RESPONSE TO REQUEST FOR ADDITIONAL INFORMATION

APR1400 Design Certification

Docket No. 52-046

RAI No.: 306-8240
SRP Section: 06.02.06 - Containment Leakage Testing
Application Section: 6.2.6
Date of RAI Issue: 11/16/2015

**Figure 6.2.4-1 Containment Isolation Valve Arrangement (11 of 13)**

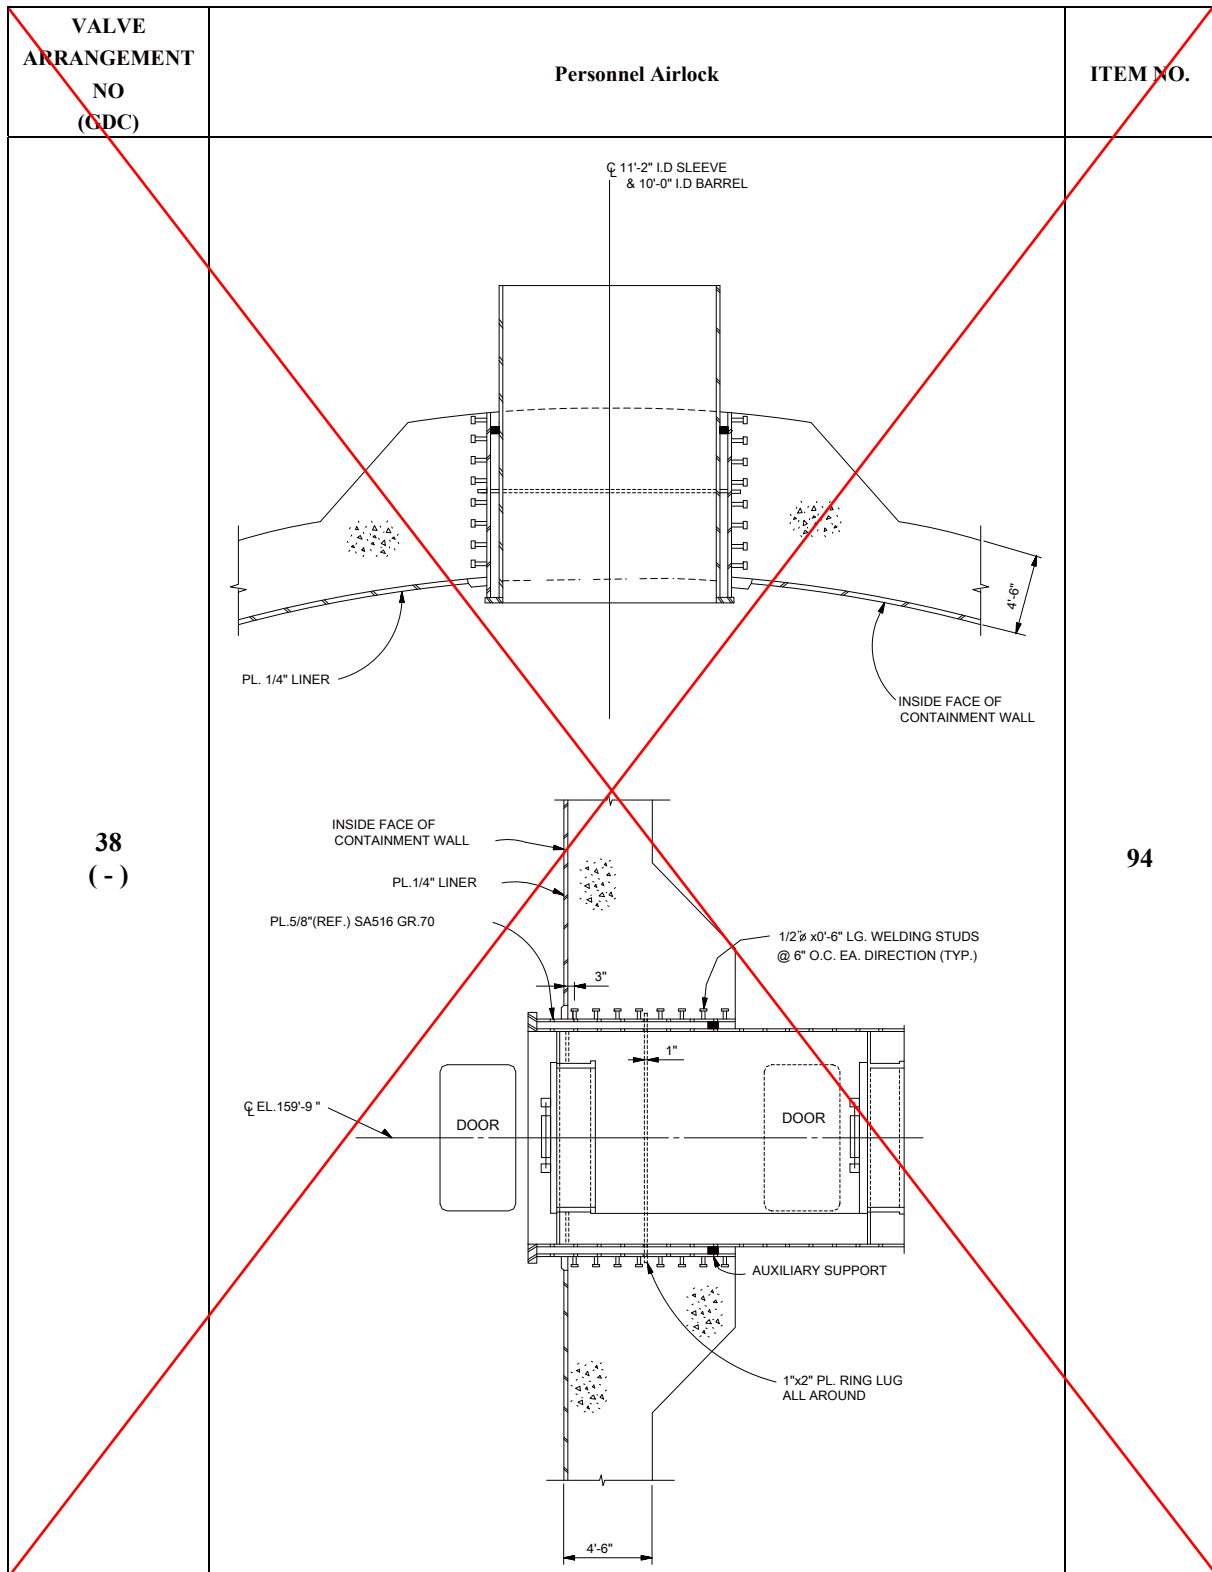
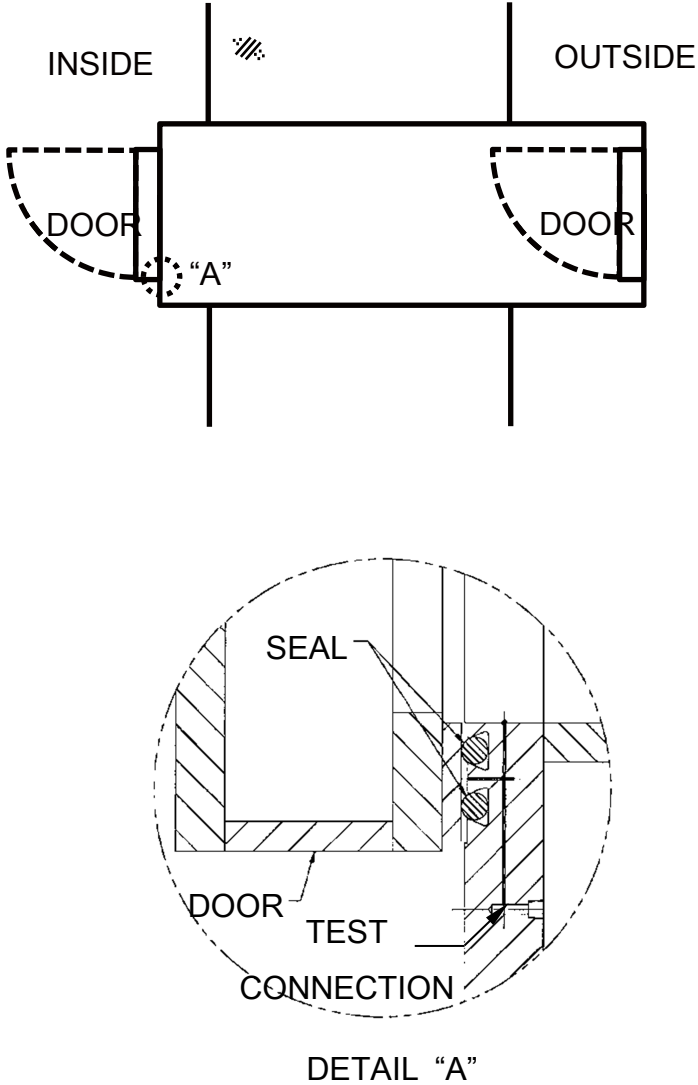
DCD Tier 2, Section 6.2.6.2 briefly discusses the Appendix J, Option B, Type B, leakage rate testing of containment penetrations and mentions Type B tests of personnel airlocks, the equipment hatch, fuel transfer tube flange and electrical penetrations. DCD Tier 2, Figure 6.2.4-1 Sheets 11 and 12 show the airlock and equipment hatch. However, they do not show any leak test connections or the seal arrangements. Please provide this information in the DCD.

DCD Tier 2, Figure 6.2.4-1 Sheets 11 and 12 will be revised to show the leak test connections in the personnel airlock and equipment hatch, respectively.
